6-D-21-HZ
APPLICATION FOR CERTIFICATE OF APPROPRIATENESS

1329 Armstrong Ave. 37917
Old North Knoxville H

Staff Report

File Number: 6-D-21-HZ

PROPOSED SCREENED PORCH
1329 ARMSTRONG AVE.
(NORTH SIDE)

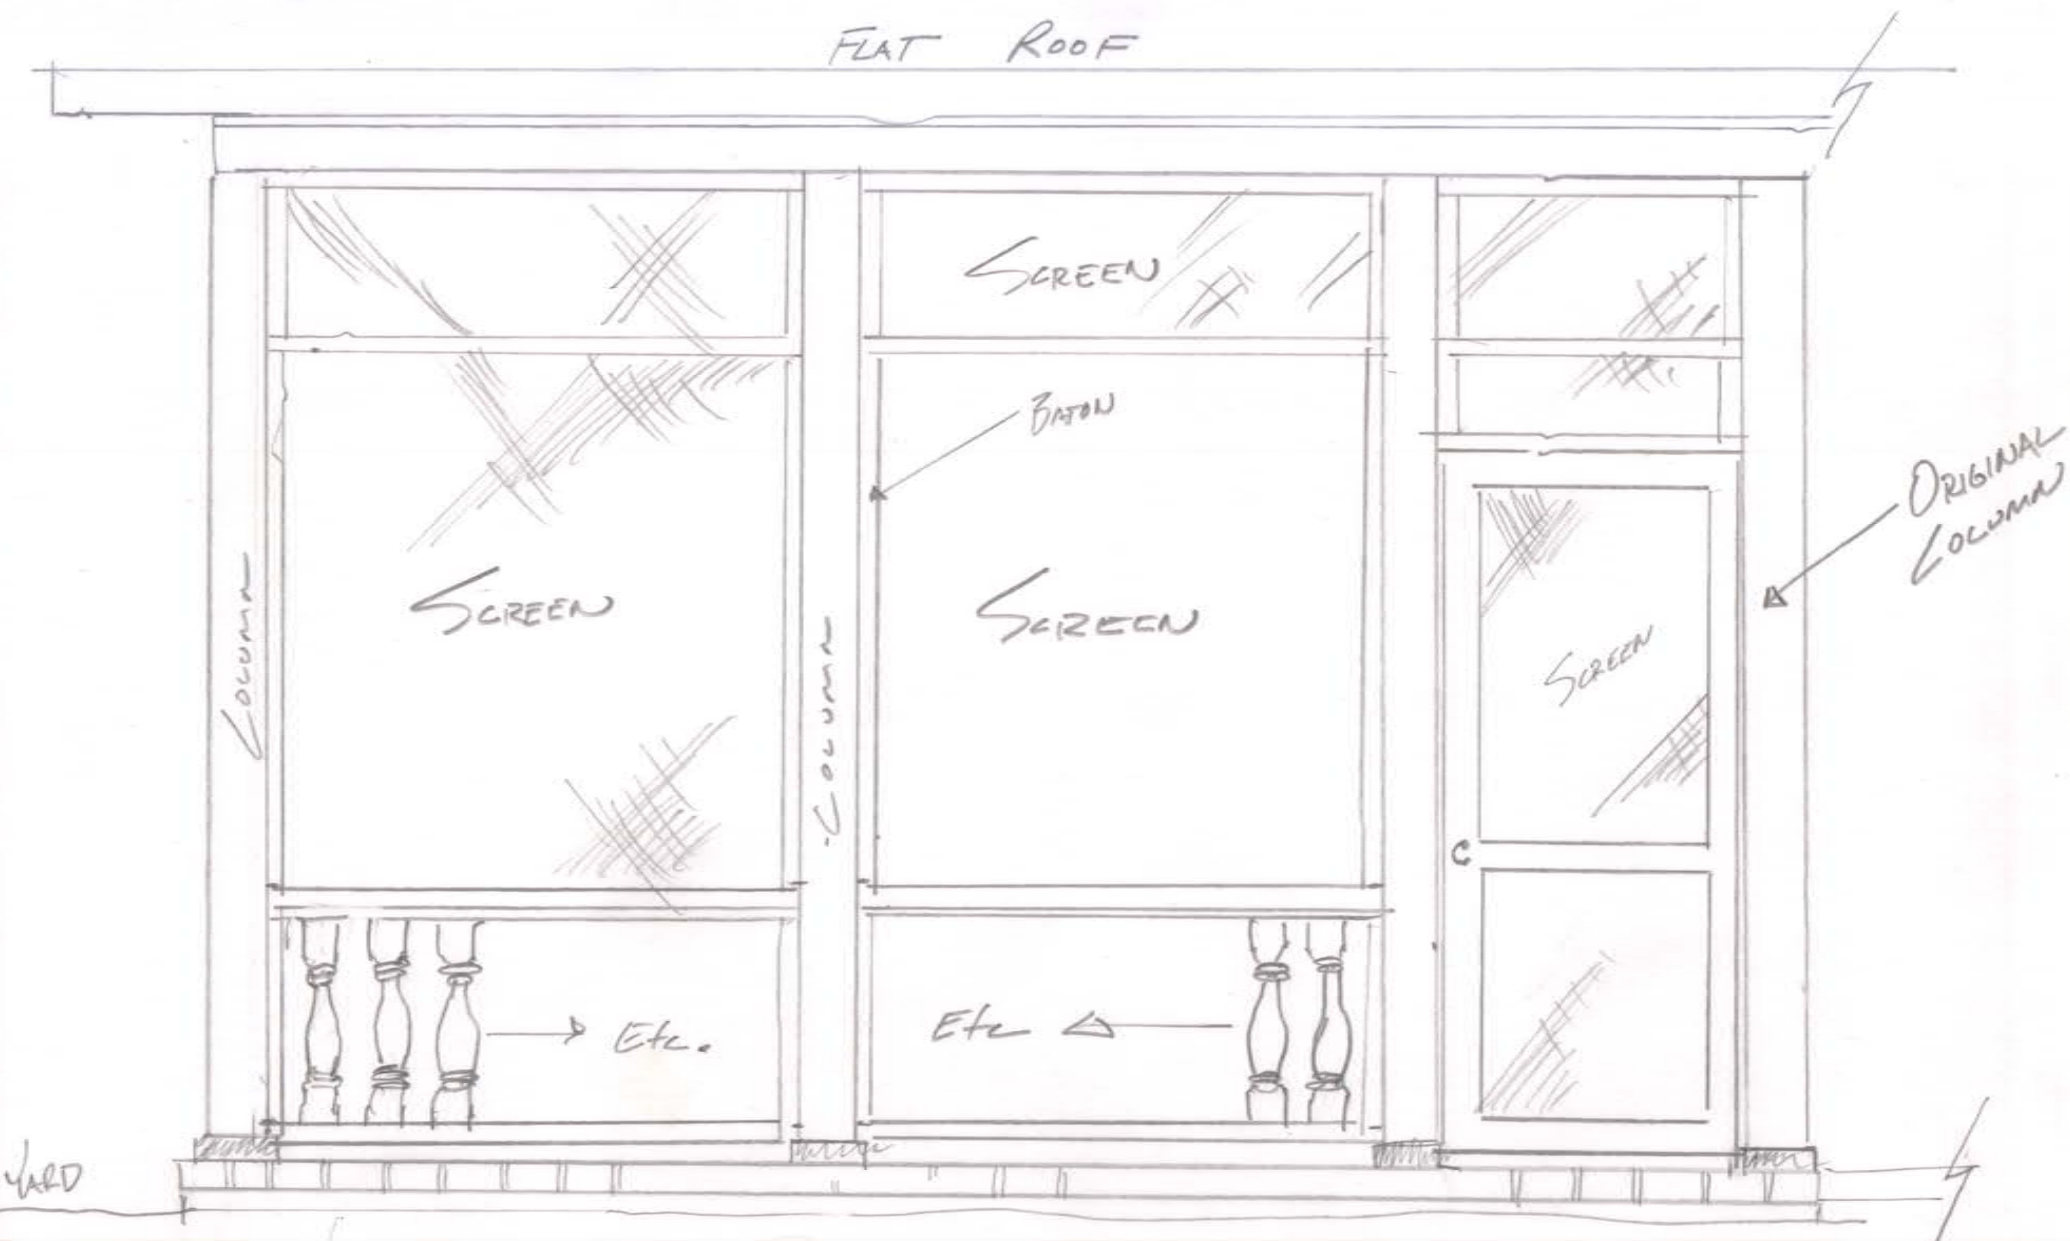
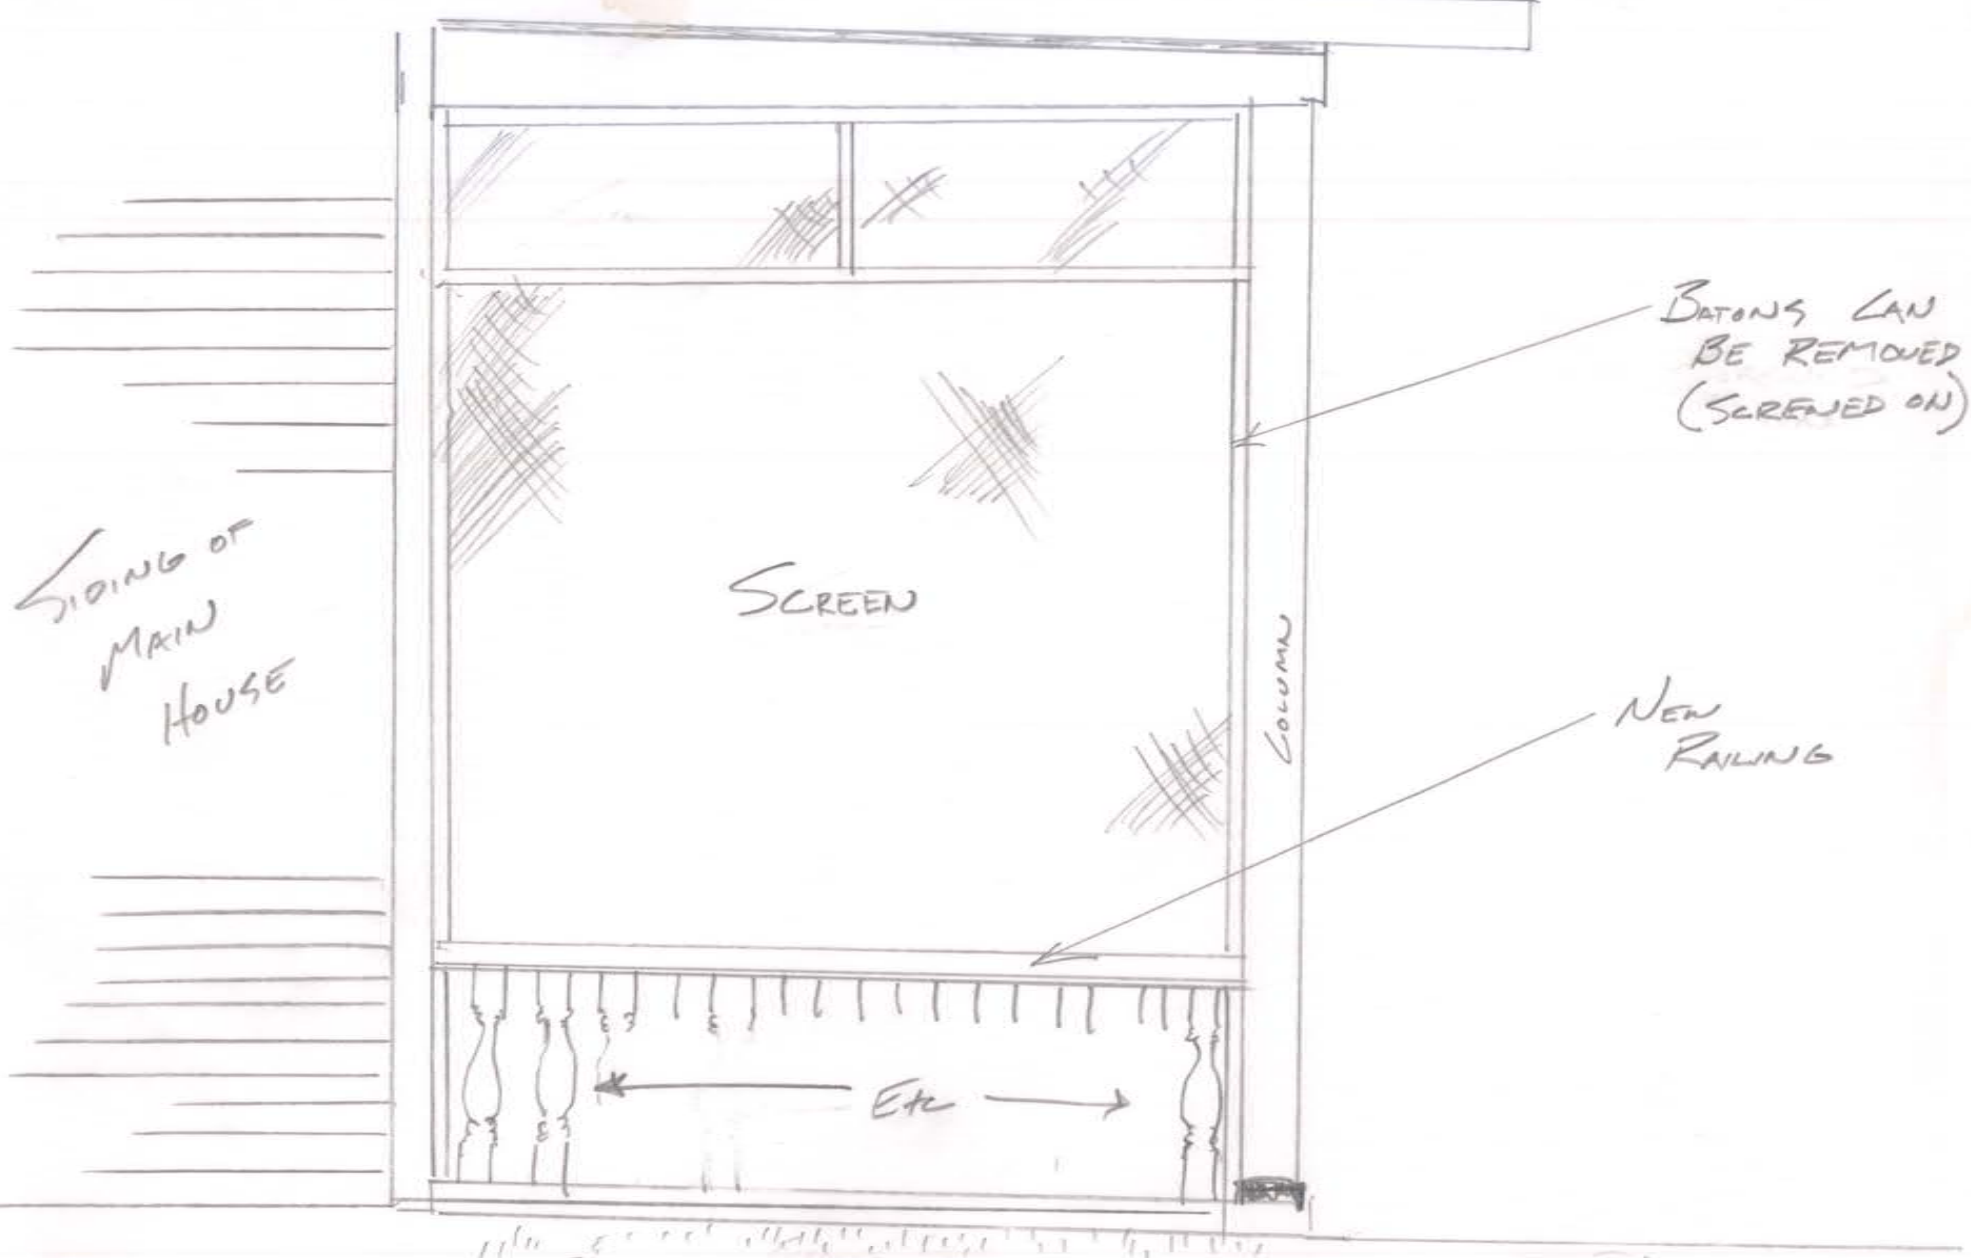
4. The installation of a new balustrade and handrail to match the front porch will create a sense of visual symmetry from Kenyon Street, with compatible front and rear porch elements. The new balustrade and handrail should match the front porch in design, size, and detail. Balusters should be set into the top and bottom rail.

Staff recommends approval of the work as proposed, with the conditions that 1) new balustrade and handrail match the front porch in design and size, with balusters set into the top and bottom rails; 2) if any of the rear columns are proposed for replacement, final specifications with dimensions should be submitted to staff for approval.
